## Deadline 2 Representation 2<sup>nd</sup> June 2021

**David and Belinda Grant, [REDACTED], Middleton-cum-Fordley, Suffolk. [REDACTED]**  
**Holders of 'Best Small Farm in Suffolk' and special award for 'Best Conservation' by SAA since 2019.**

This is our Deadline 2 Summary Representation together with Annexes to the Planning Inspectorate regarding the proposed Sizewell C nuclear development (SZC) currently before the Planning Inspectorate under DCO submission.

# Heritage Assessment

PROJECT SIZEWELL C LINK ROAD		DATE 19.05.21		DRAWING STATUS INFORMATION		
DRAWING TITLE FORDLEY ROAD OPTIONS		SCALE(S) 1:2000 @ A1		DESIGNED SC	DRAWN SC	
		JOB No  P20-2187		CHECKED PZ	APPROVED PZ	
				CLIENT DAVID GRANT (MIDDLETON)		
		DRAWING No 03_001		REVISION A		create CONSULTING ENGINEERS LTD

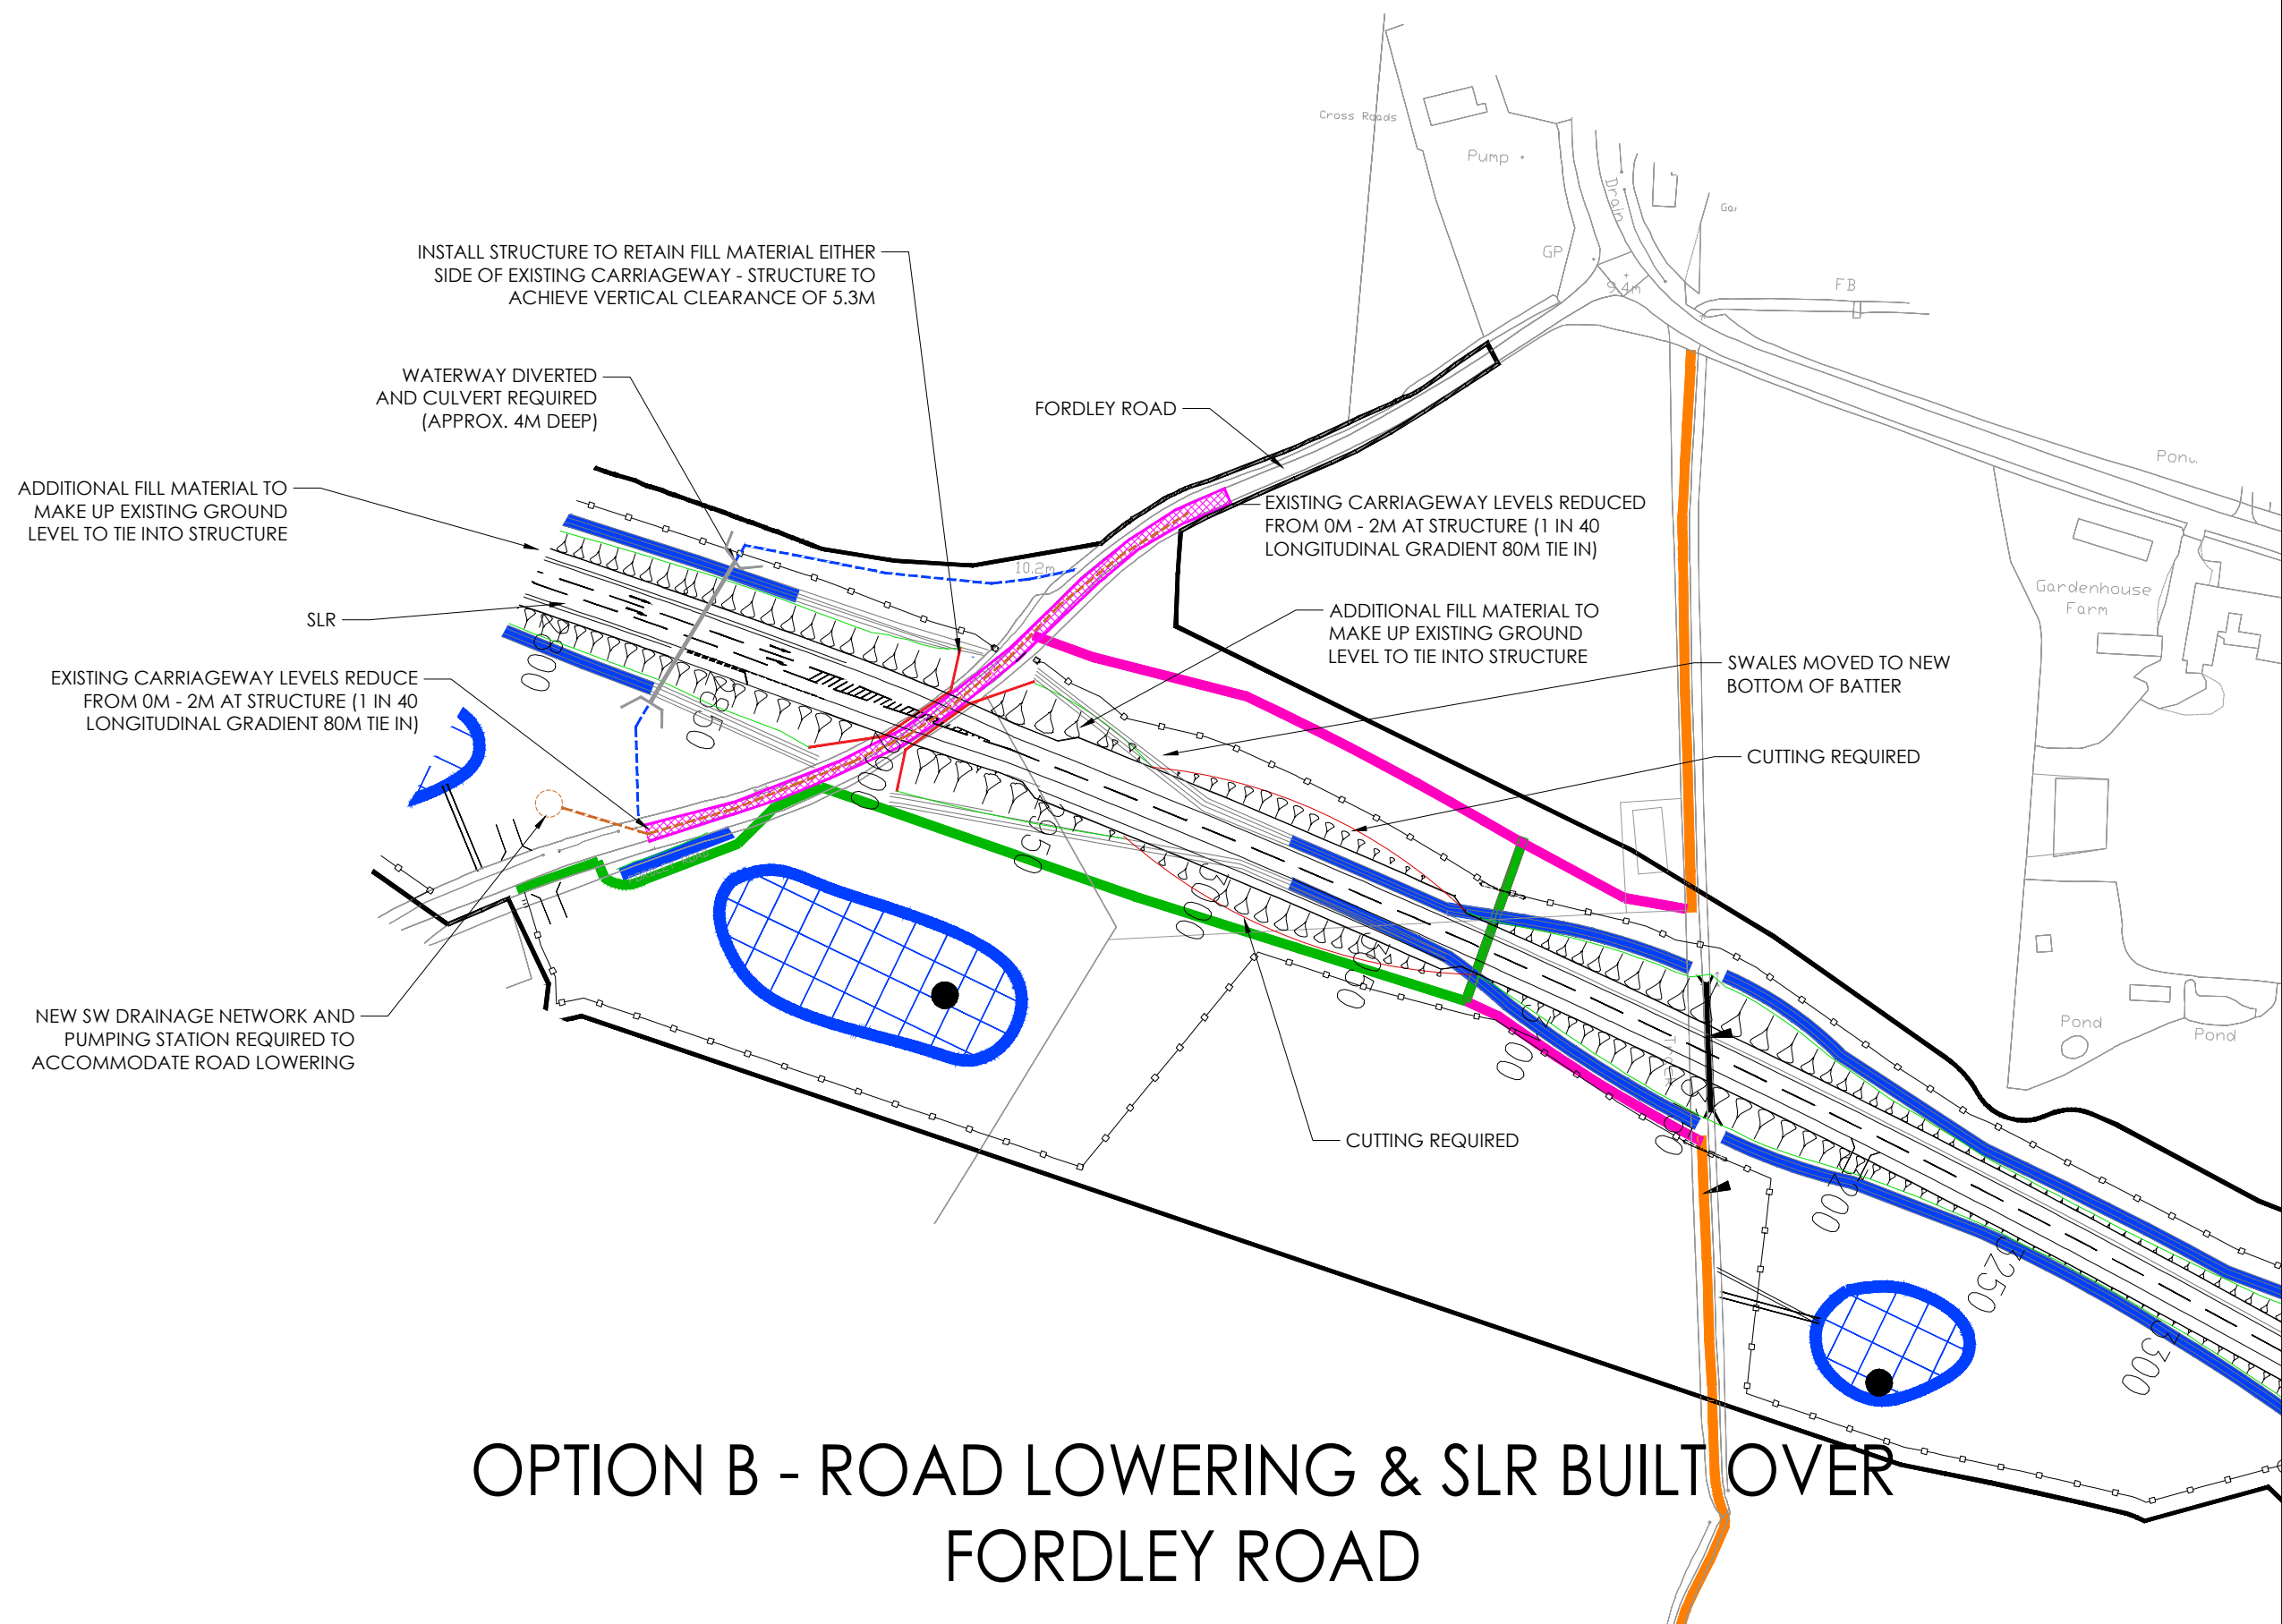
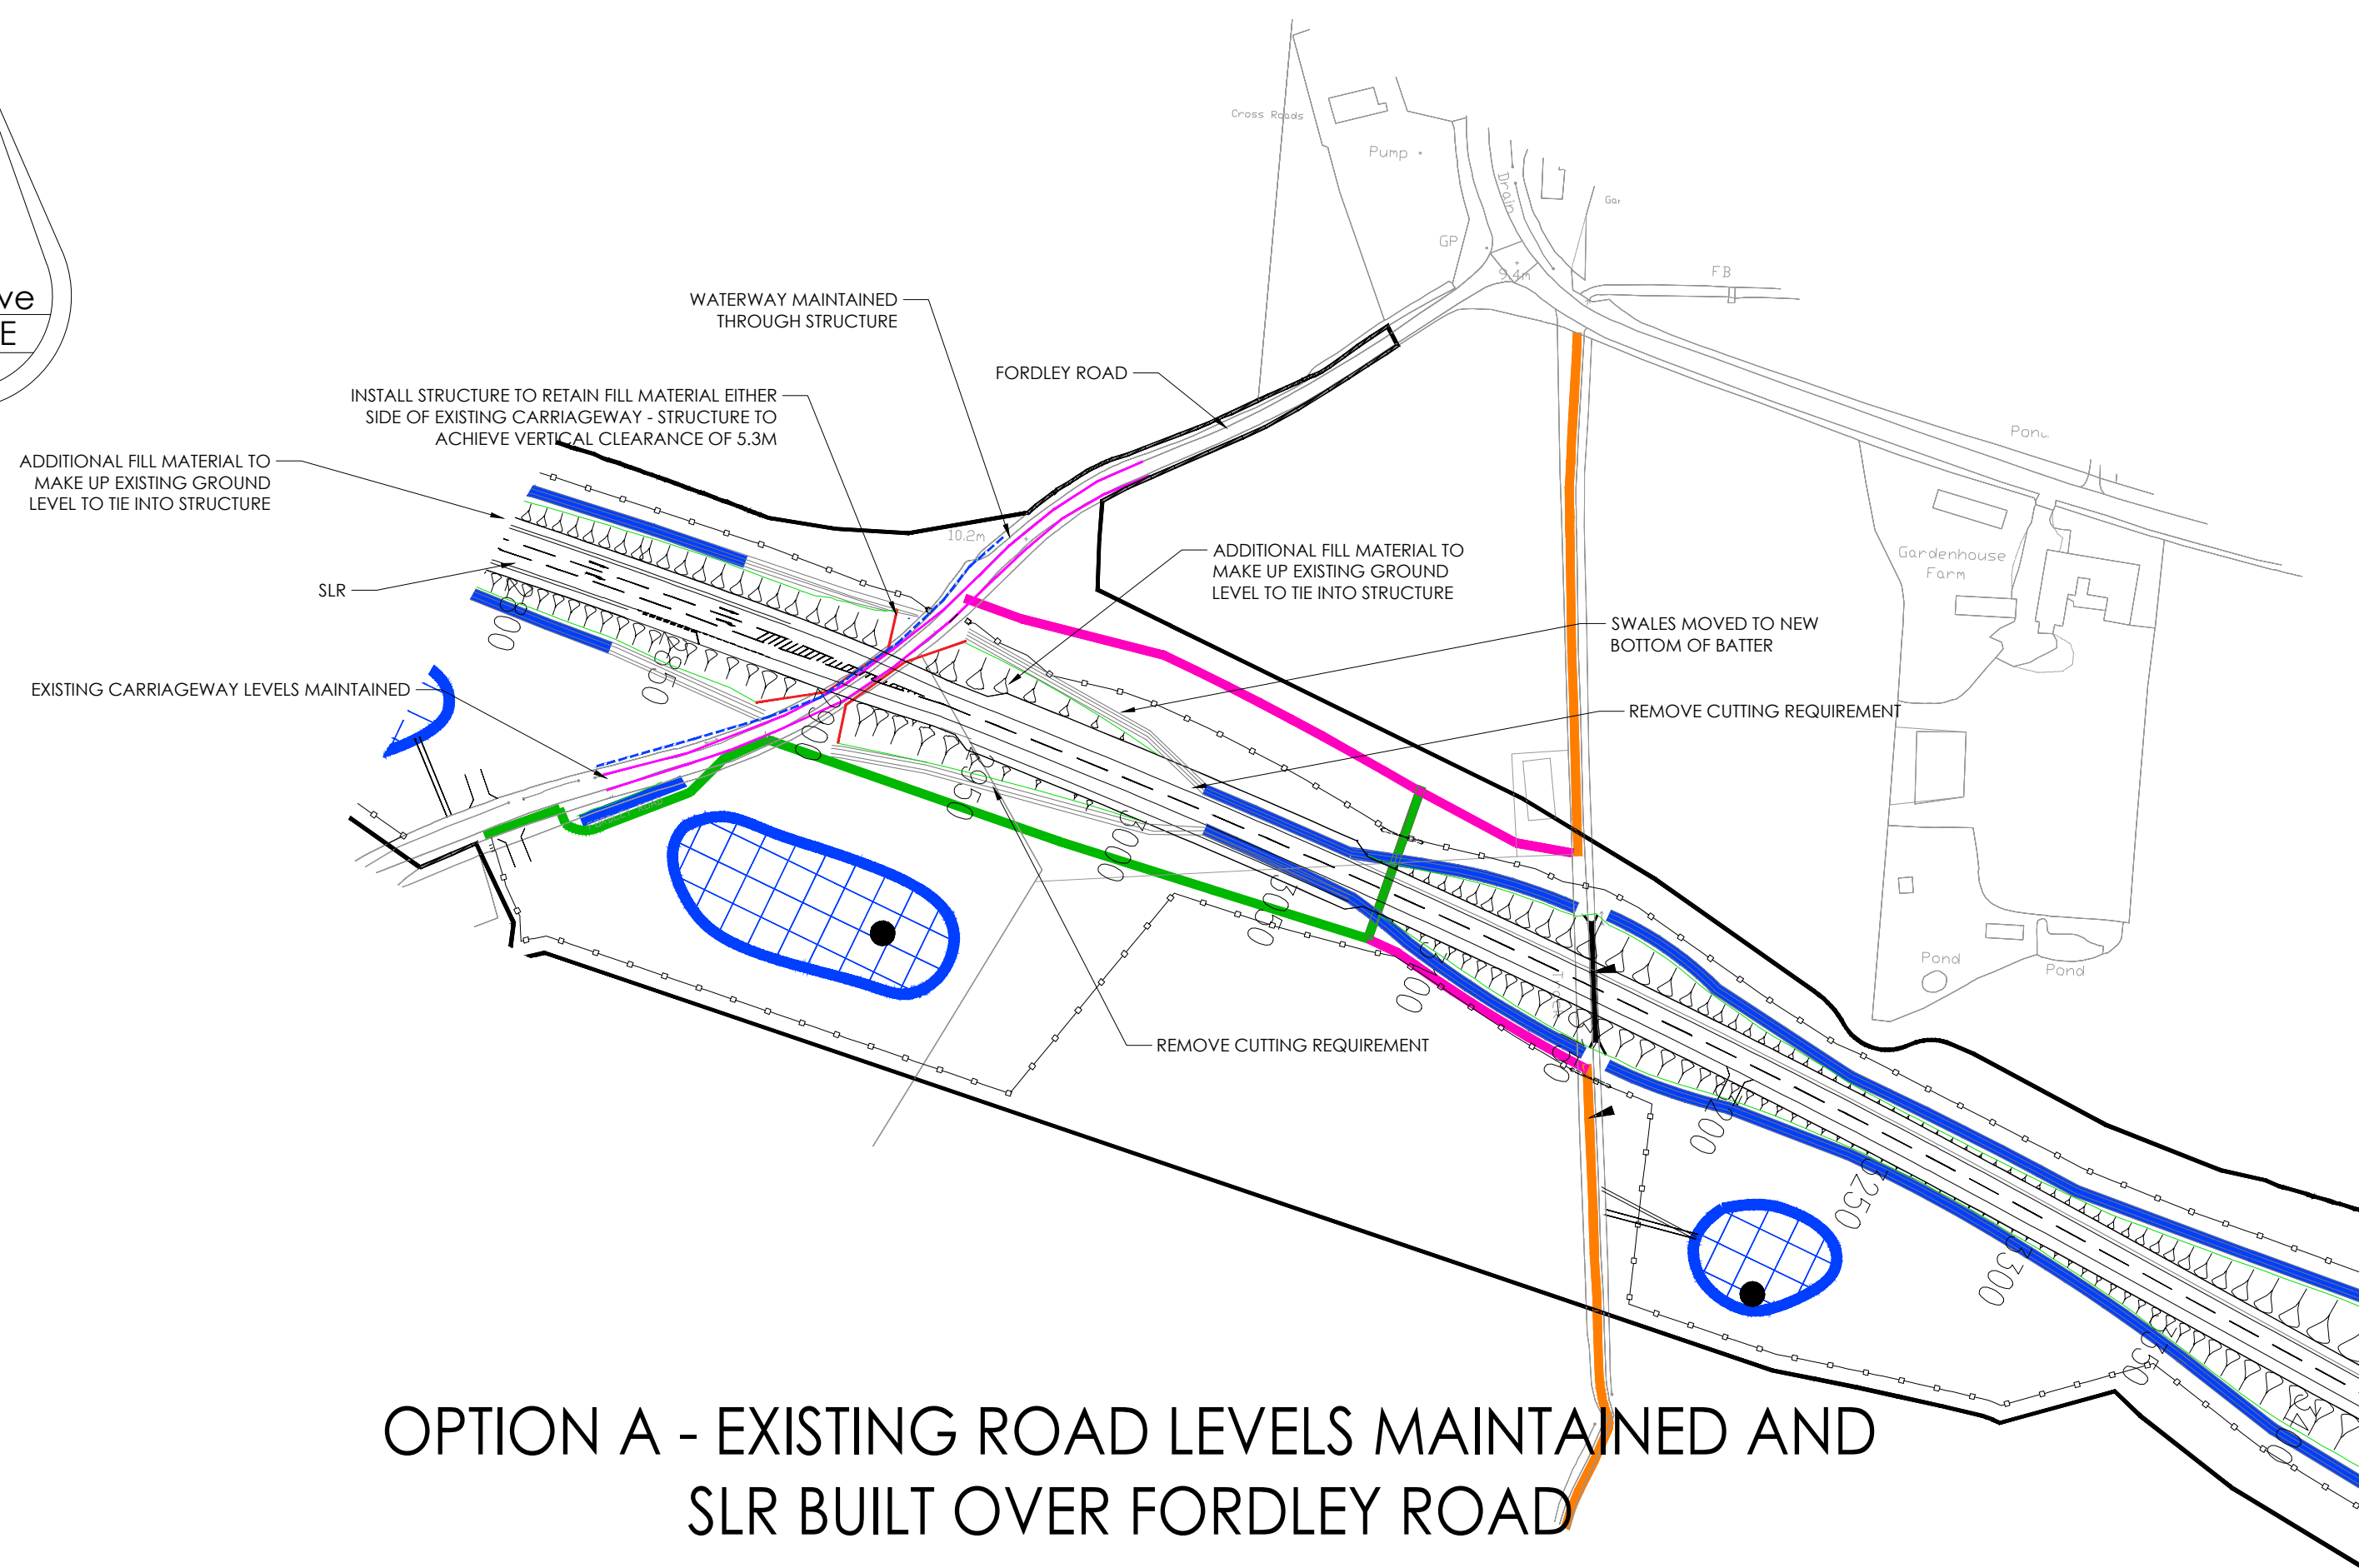
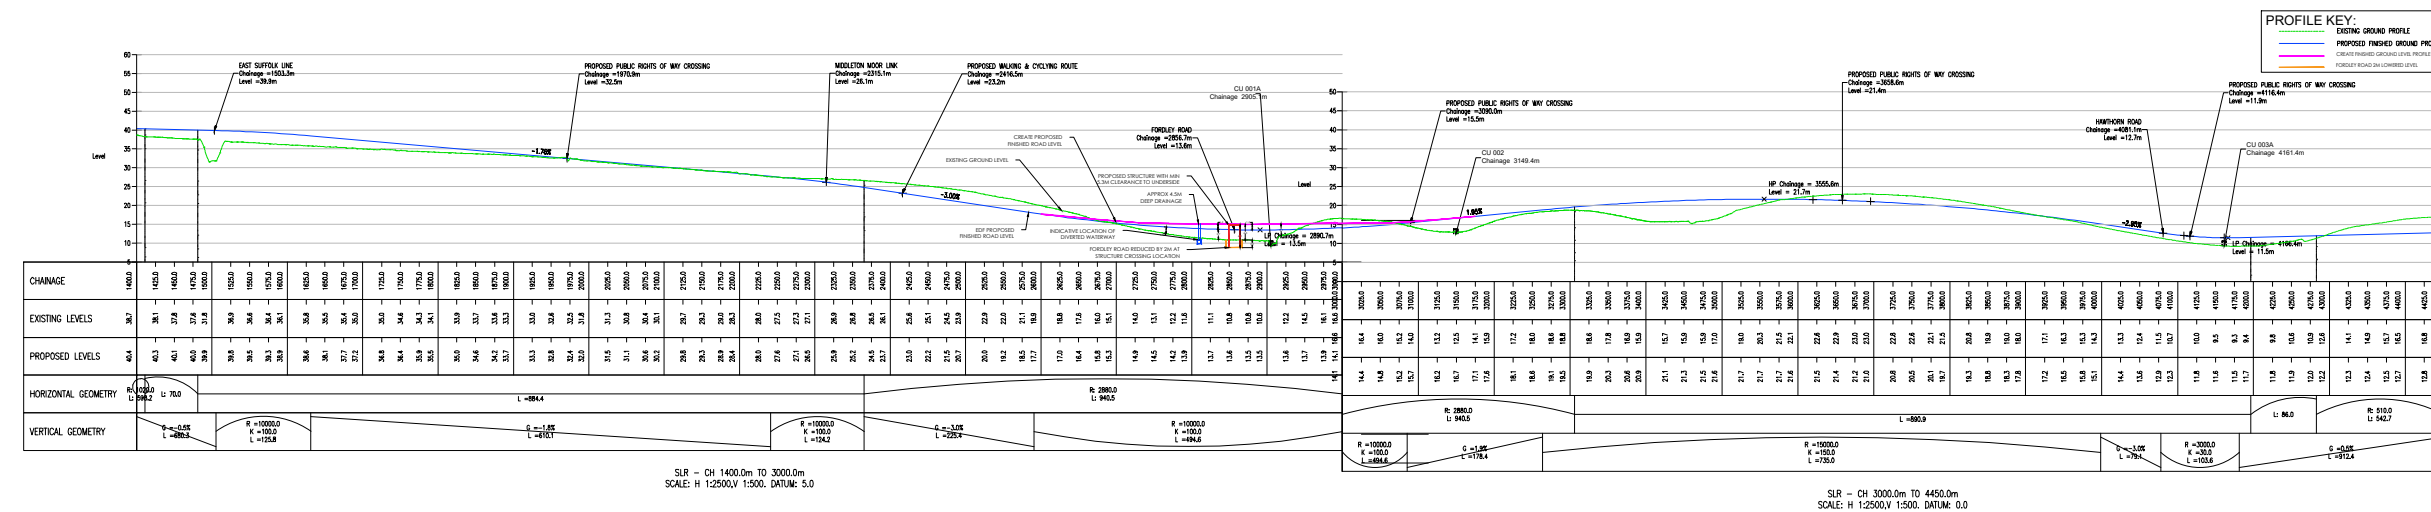
Therefore, Fordley Road must not be allowed direct access to the SLR; it needs to be retained to continue its current function of access to the B1122 for the local communities – hence our proposal to the Inspectors and the Applicant for Fordley Road to pass **below the proposed SLR**. Our consultants Create, confirm that this is not a great challenge from an engineering perspective and the SLR could then be reduced in width by 33% at the crossing point. Such a passage below the SLR could even be single track, with traffic lights to control directional traffic flow, whilst at the same time creating a permanent traffic calming measure.

Taking Fordley Road **under the SLR** will also provide access for emergency services to Middleton and Fordley communities (including the residential Nursing Home on Middleton Moor) in the event of closure of the A12 or an accident on the SLR itself.

- 4.2 Create have shown that the SLR / Fordley Road junction proposal is not safe for a number of reasons.
- 4.3 Create requests the Applicant revisits the Fordley Road link with a view to removing the SLR junction.

<b>Current EDF Proposal</b>	Cut off Fordley Road at the junction with the SLR and make access to the north of the SLR redundant from Fordley Road. Diversion requiring a 2km diversion route to access north side of Fordley road.	<ul style="list-style-type: none"> <li>• Cut off Fordley Road north of SLR</li> <li>• 2km diversion route created requiring northbound or southbound Fordley Road traffic to use SLR to access north side of Fordley Road</li> <li>• Cut and fill earthworks to build up ground profile</li> <li>• Earthworks to build up slip road</li> <li>• Divert waterway beneath SLR</li> <li>• Construct a turning head north side of Fordley Road to allow traffic to turn around</li> <li>• Cut off traffic flow along Fordley Road during construction phase</li> </ul>
